TECHNICAL SERVICE BULLETIN

Date: 06/28/95

merit industries, inc.

Figure 1 - Location of EPROM in JCM Black Stallion Bill Acceptor

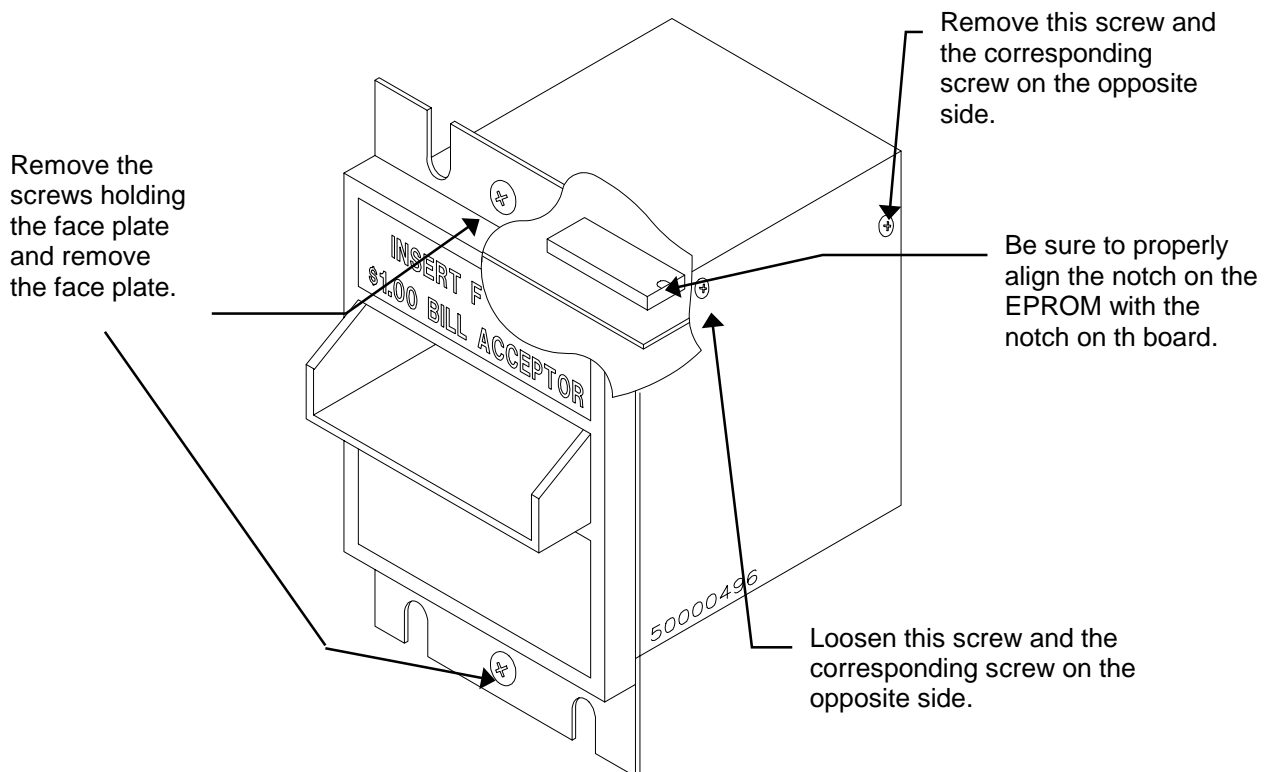
- Problem:** JCM Black Stallion bill acceptor not accepting bills.
- Games affected:** All games with JCM Black Stallion bill acceptors.
- Symptoms:** Not taking bills, lights flashing.
- Cause:** Bad program EPROM.
- Solution:** Update EPROM in Black Stallion bill acceptor. Available from JCM at 1-800-683-7248, your local distributor or Merit Customer Service at 1-800-445-9353.

Refer to Figure 1 for all instructions.

1. Remove the face plate screws and the face plate
2. Remove the screws holding the lid and remove the lid.
3. Remove the existing EPROM.
1. Install the new EPROM being careful to align the notch on the EPROM with the notch on the board.
